Request for Class II Permissive Change(C2PC)

FCC ID: VG8EM720DXX

This is a C2PC application for which the previous grant was issued on 2012-12-05.

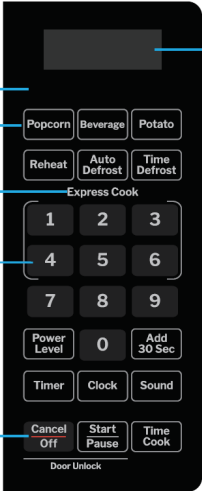
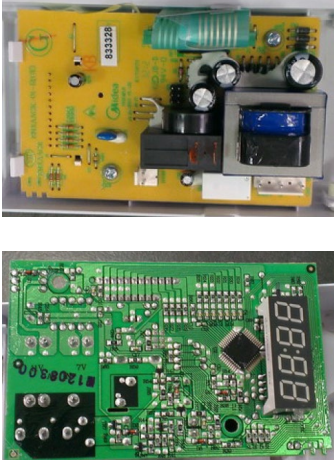
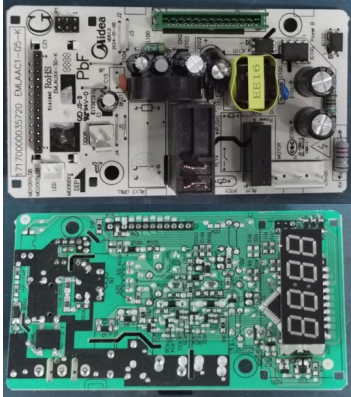
No.:	Original	New	Difference(s)
1			Keypad: Updated front keypad to accommodate child lock function (Child resistant oven door function).
2			Mother board: Modified the peripheral circuit (non-RF circuit) and some individual components and PCB layout. The magnetron and other circuit are exactly same as before.

3	Not Applicable		The new one adds a solenoid valve locking mechanism, the original is not.
---	----------------	---	---
